Access Compliance Report Public Rights-of-Way (Curb Ramps)

Intersection ID: 42924 Main Street: BRAY DR Cross Street: KILRUSH DR Location: ADA ID: 629394777B2A Ramp Type: PerpDiag Initial Pass/Fail: Fail **Overall Compliance: No** Severity Score: 33.75

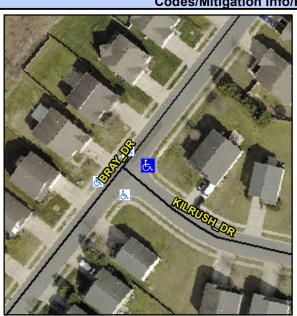
Possible Solutions: Remove & Replace Curb Ramp With Two New Directional Ramps or Equivalent. Surveyor Notes: N/A PROW/ADA: Not Found, R304.5.1, R304.2.2, R304.5.3

Field Measurements/Component Compliance						
	Compliance Description		Data	Comp	liance Description	Data
	N/A	Ramp Length (in)	46.0	No	Ramp Slope (%)	11.2
	No	Ramp Width (in)	39.0	No	Ramp XSlope (%)	6.1
	N/A	Flare Type LT	N/A	N/A	Flare Type RT	N/A
	N/A	Flare Slope LT (%)	N/A	N/A	Flare Slope RT (%)	N/A
	N/A	Flare Traversable LT?	N/A	N/A	Flare Traversable RT?	N/A
	N/A	Landing Length (in)	N/A	N/A	DWS Provided?	N/A
	N/A	Landing Width (in)	N/A	N/A	DWS Contrast?	N/A
	N/A	Landing Slope (%)	N/A	N/A	DWS Length (in)	N/A
	N/A	Landing X Slope (%)	N/A	N/A	DWS Full Width?	N/A
	N/A	Landing Curb? (Y/N)	N/A	N/A	DWS Offset (in)	N/A
	N/A	Shared Landing?	N/A			
	N/A	Gutter Ponding?	N/A	N/A	Gutter Slope (%)	N/A
	N/A	Gutter Lip Ht (in)	N/A	N/A	Gutter X Slope (%)	N/A
	N/A	Painted X Walk1?	No	N/A	Painted X Walk2?	No
		X Walk 1 Direction	To NW		X Walk 2 Direction	To SW
	N/A	X Walk 1 Width (in)	N/A	N/A	X Walk 2 Width (in)	N/A
		X Walk 1 Slope (%)	2.0		X Walk 2 Slope (%)	1.1
